Ref. No.171-00927 Task 2

RE: Addendum Traffic Impact Statement, Proposed Multi-Tenant Residential Building with Ground Floor Commercial Space, 651 Portland Hills Drive, Dartmouth (WSP May 10, 2016)

This Addendum to *Traffic Impact Statement, Proposed Multi-Tenant Residential Building with Ground Floor Commercial Space, 651 Portland Hills Drive, Dartmouth* (WSP, May 10, 2016; copy attached Pages B-1 to B-5) has been prepared in response to HRM comments (copy attached, Pages B-6 and B-7) regarding Case # 20573 (July 18, 2016). The Addendum includes an update to the level of service analysis for the Portland Street / Portland Hills Drive / Regal Road intersection.

SITE PLAN

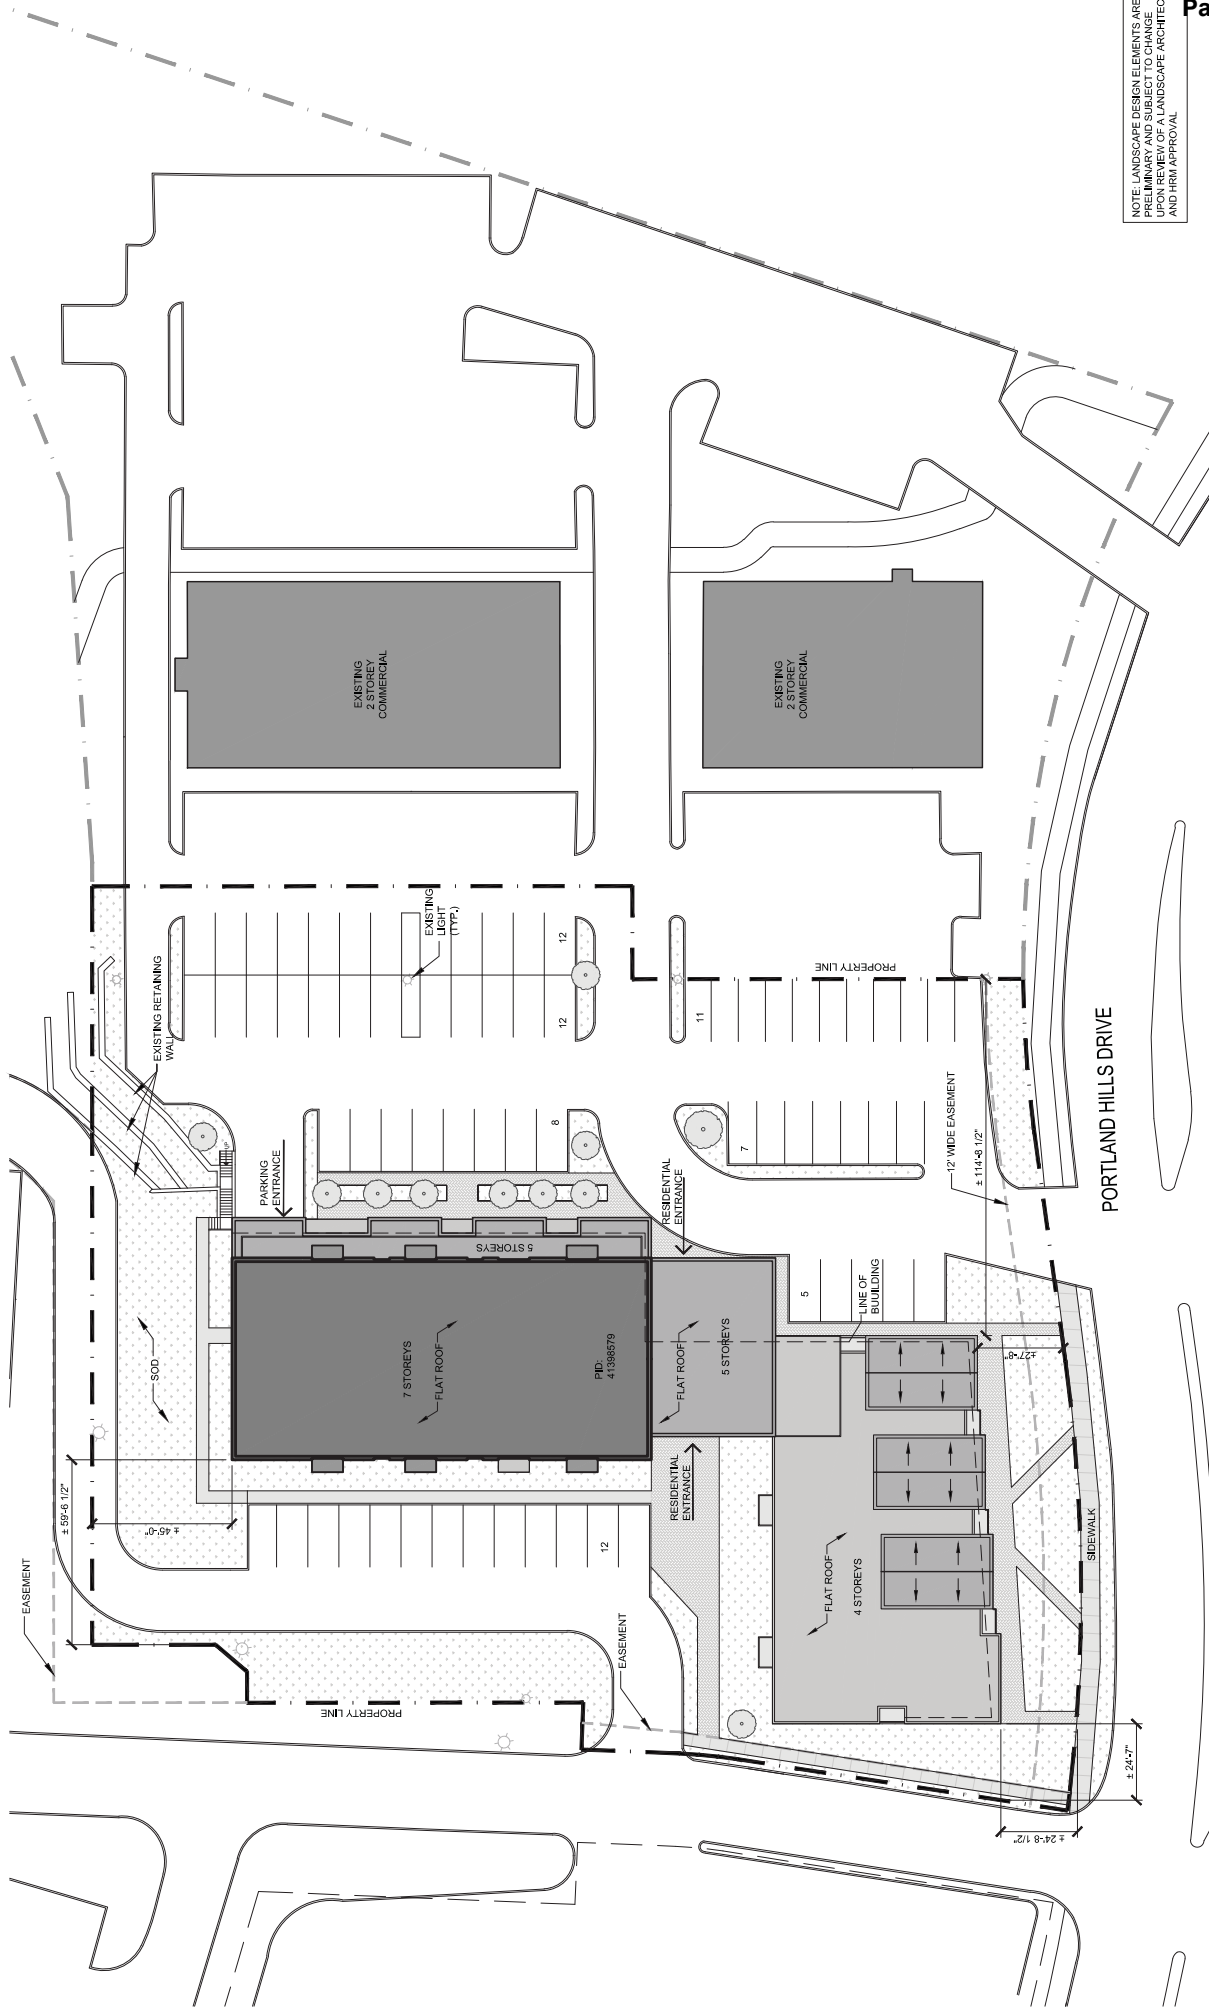
- There is no justification provided for the one-way driveway exit to the park & ride lot. Traffic Services opinion is that this additional access is not required as the 12 parking spaces can exit at the park & ride driveway. Having them exit into the park & ride lot would only result in looping back around onto the park & ride driveway.

- Providing a pedestrian connection to the park & ride would be beneficial.
 - The proposed development opposite 651 Portland Hills Drive is mentioned in the report but they fail to provide information on the potential right turn slip lane that may be required to increase the level of service at the intersection of Portland Street/Portland Hills Drive/Regal Road. This report should include an updated level of service analysis to ensure further traffic mitigation measures are not required.

Additional Site Exit - A one-way driveway exit with sidewalk is proposed from the parking area at the north side of the building to the Park & Ride lot (Figure 1). The exit driveway meets the Park & Ride lot in an area that does not have parking spaces. There is good visibility for both approaches where the site exit meets the parking lot as illustrated in Photos 5 and 6.
